**PRODUCT NOTICE**
Notice of Potential Product Concern

**Logix Controller Firmware Revisions 16 and 17,
Fault Recovery**

Reference: 2010-01-001

Date: January 2010

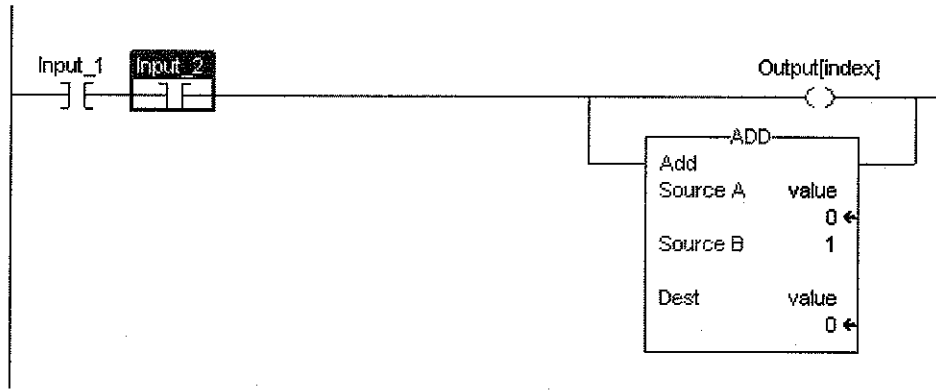
There is an anomaly when these methods attempt to handle a fault.

- Anomalous program execution. For example, if a rung is being scanned false and there is an instruction that has false execution, the fault handler executes so the remainder of the rung will scan true. In the example below, the OTE instruction has an index out of range. After returning from the fault handler, the ADD instruction will execute, even though the rung input conditions are false.

- In a redundancy system, remove all Add-On Instructions from the fault handlers and power-up handler.
- Correct any code that could cause a major recoverable fault.
- Do not allow an indirect address to be out-of-range, even in pre-scan or post-scan.
- Do not clear major recoverable faults in the fault handlers.

These anomalies will be corrected in the firmware updates contained in Table 1 below. Firmware will be available before March 31, 2010.
